Access Compliance Report Public Rights-of-Way (Pedestrian Signals)

Main Street: CROWN_VALLEY_PKWY Cross Street: SIENNA_PKWY Location: S

ADA ID: SGRK211022115329 Signal Type: One Push Button-Non APS Overall Compliance: No Severity Scores: BTN 1: 35 BTN 2: N/A No BTN: N/A

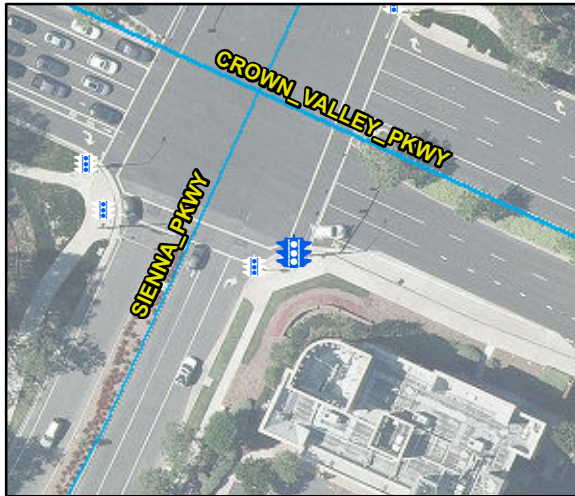
OC Std/PROW: R404.2, R404.3, MUTCD 4e.08

Possible Solutions: Replace Signal Push Button With APS Button. Remove and Replace Clear Space.
